HISTORIC PRESERVATION BOARD STAFF REPORT

202 N. Swinton Avenue

Meeting	File No.	Application Type
October 16, 2024	2024-192	Certificate of Appropriateness, Level 1 Site Plan Modification, Demolition, and Variance

A7A PROPOSED ENTRY (EAST) ELEVATION: REAR STRUCTURE

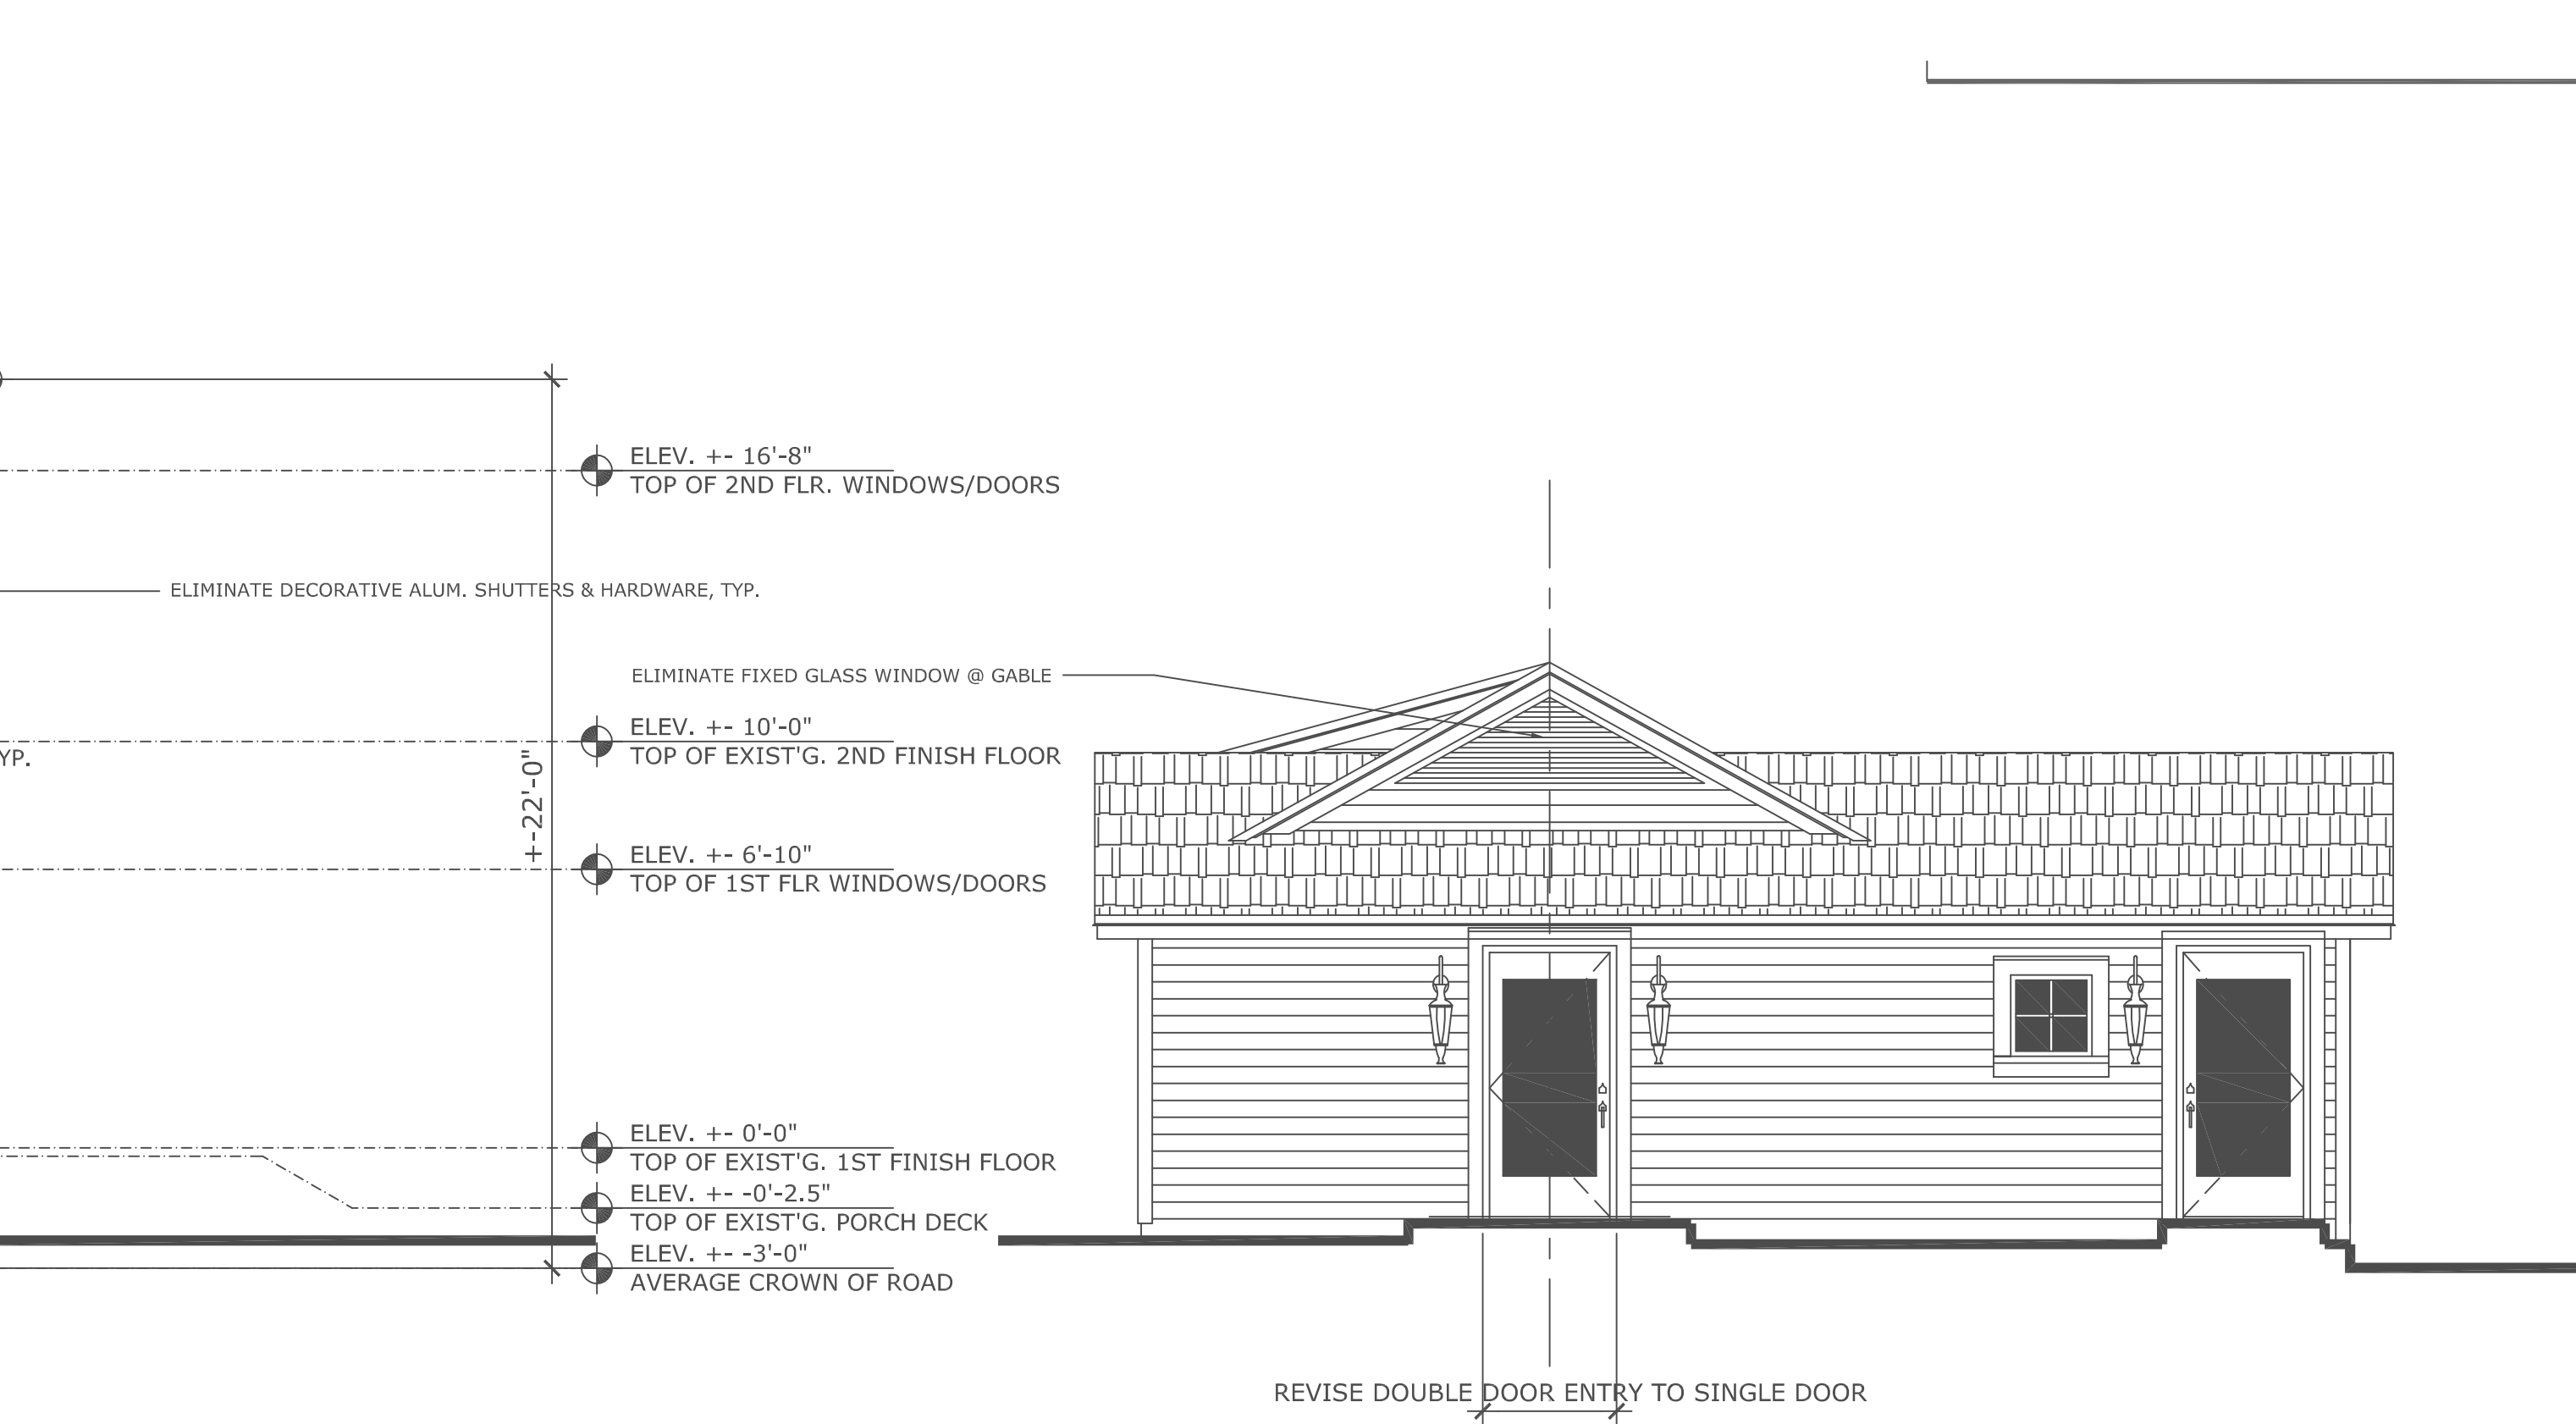
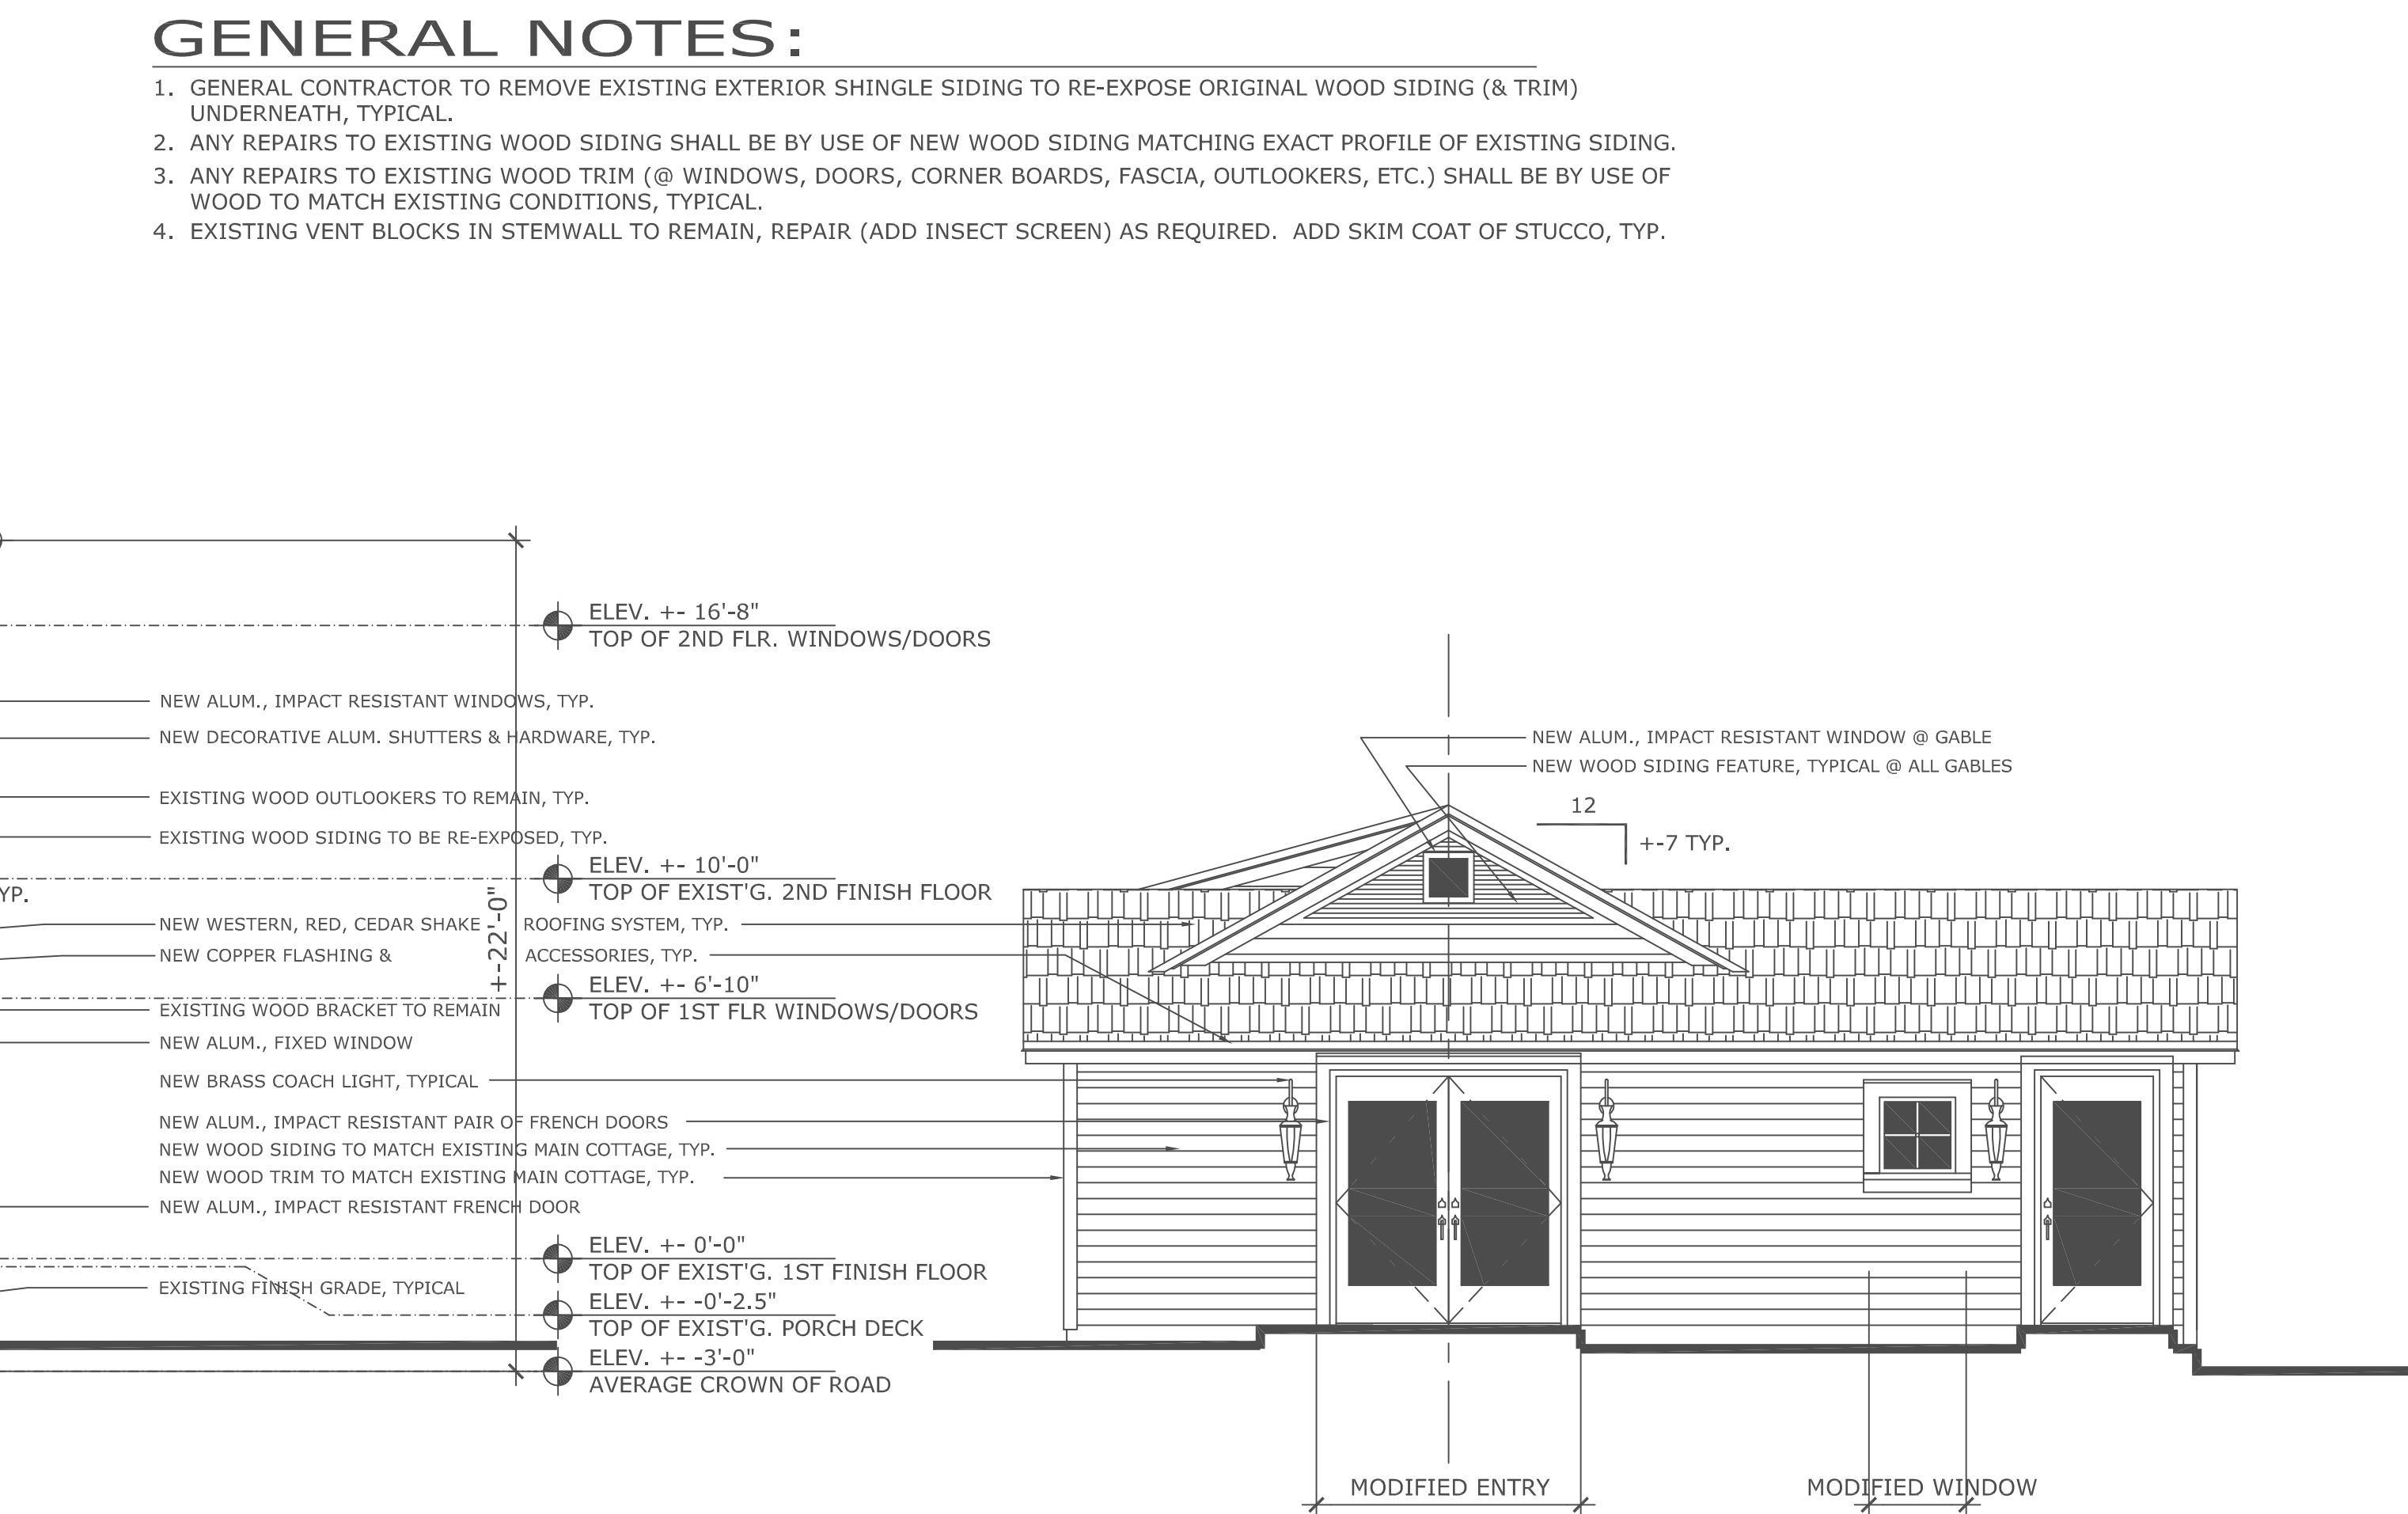
1. South Elevation: Elimination of the approved transom window above the entry door and elimination of the fixed window.
2. East Elevation: Installation of a single-entry door where a double French door was approved and elimination of the fixed glass window.
3. West Elevation: Installation of two single hung windows where a set of double French doors were approved and elimination of the approved fixed window on the gable.

4. South Elevation: Elimination of the approved transom window above the entry door and elimination of the fixed window.
5. East Elevation: Installation of a single-entry door where a double French door was approved and elimination of the fixed glass window.
6. West Elevation: Installation of two single hung windows where a set of double French doors were approved and elimination of the approved fixed window on the gable.

A8 FINAL RIGHT SIDE (NORTH) ELEVATIONS: BOTH STRUCTURES

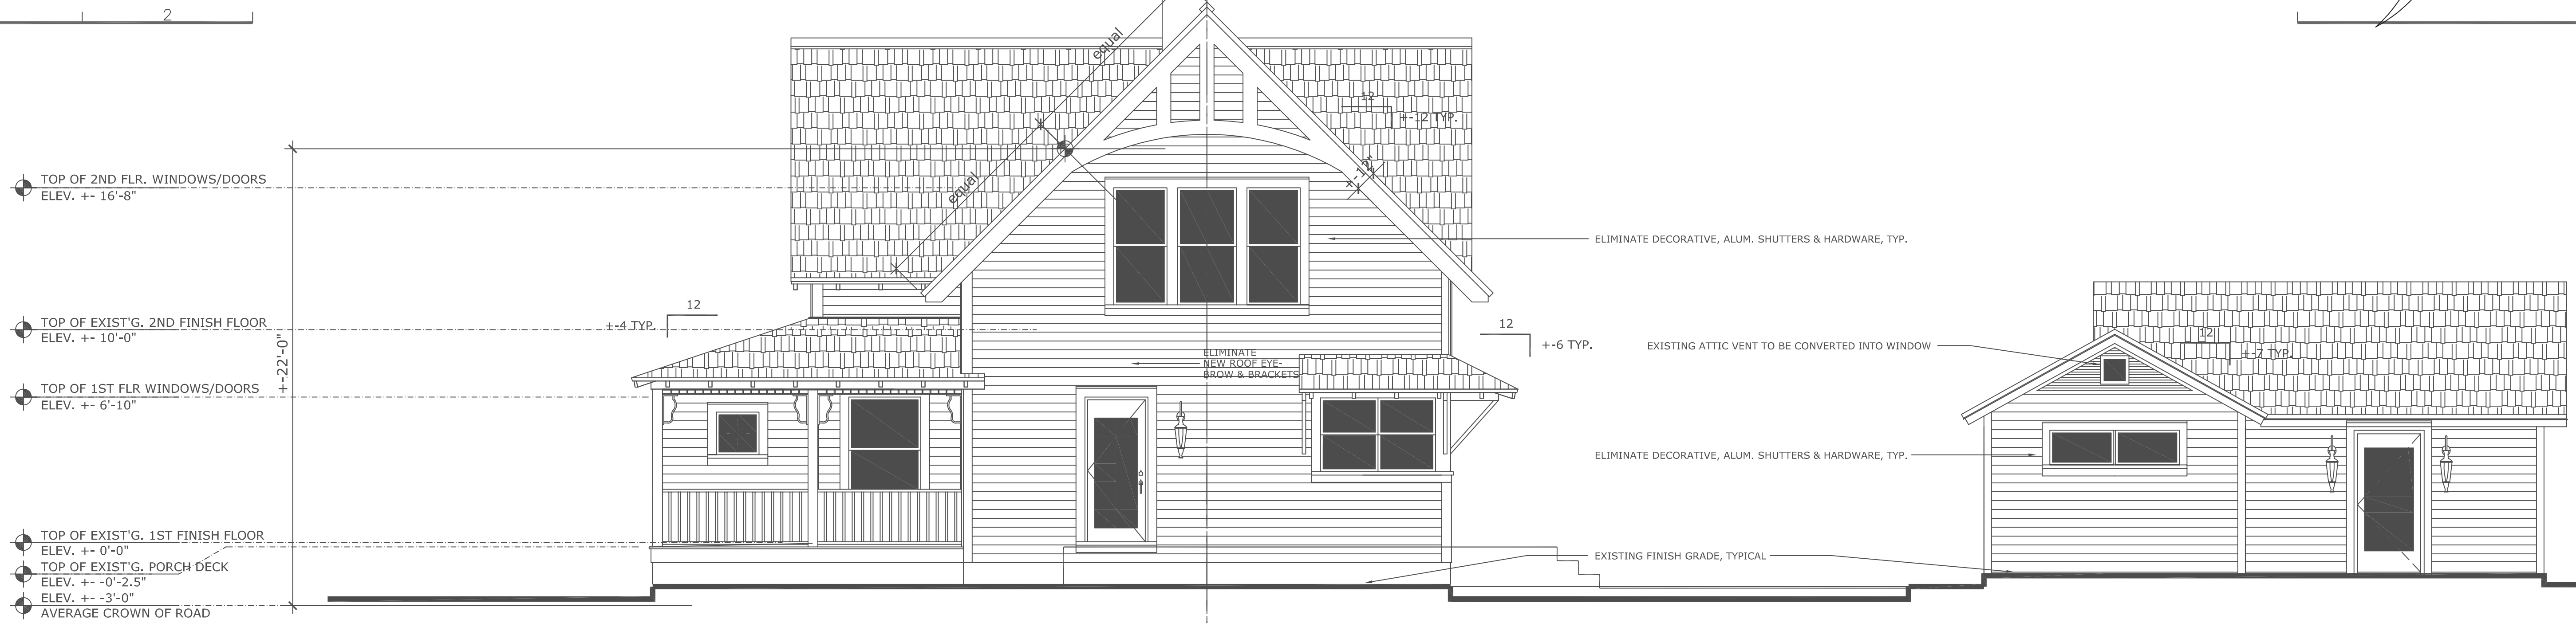
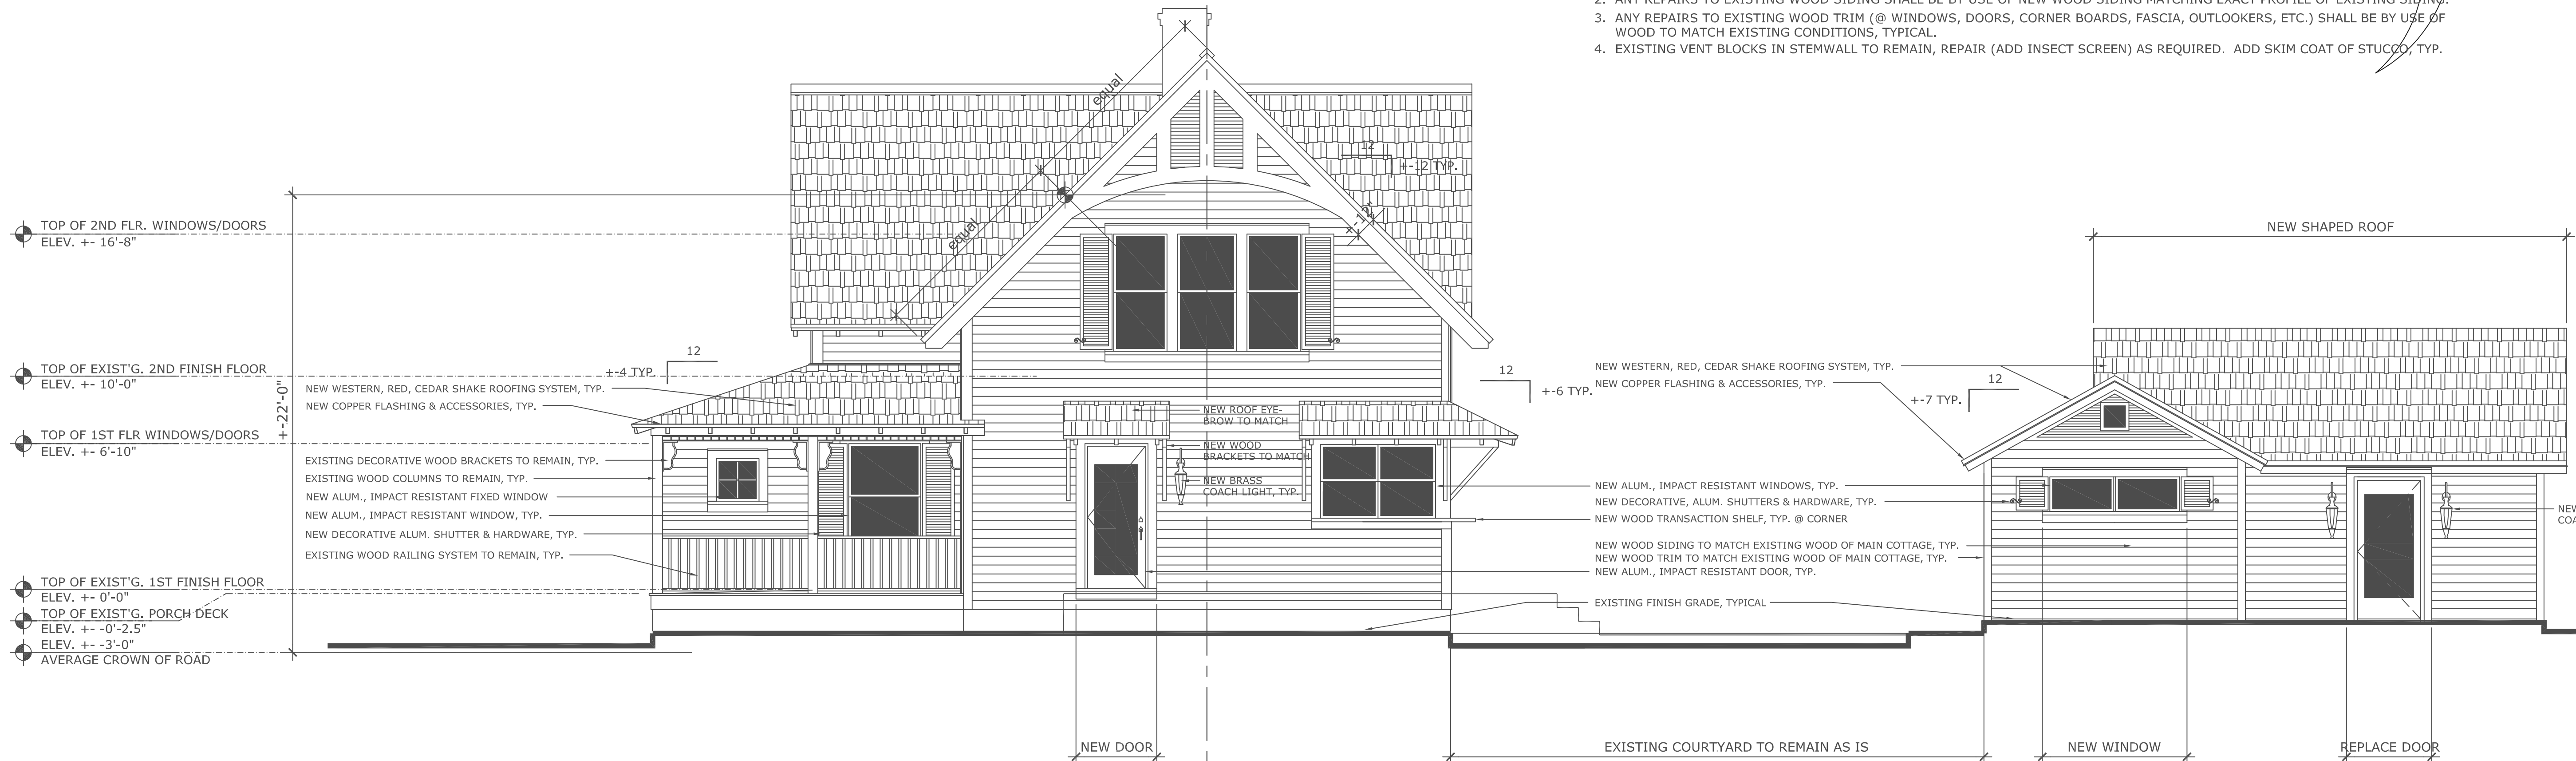
1. North Elevation: Removal of the approved roof eyebrow over the side door.
2. West Elevation: Changing the rear entry door to match all other doors, which are solid pane class doors.

3. North Elevation: Removal of the approved roof eyebrow over the side door.
4. West Elevation: Changing the rear entry door to match all other doors, which are solid pane class doors.
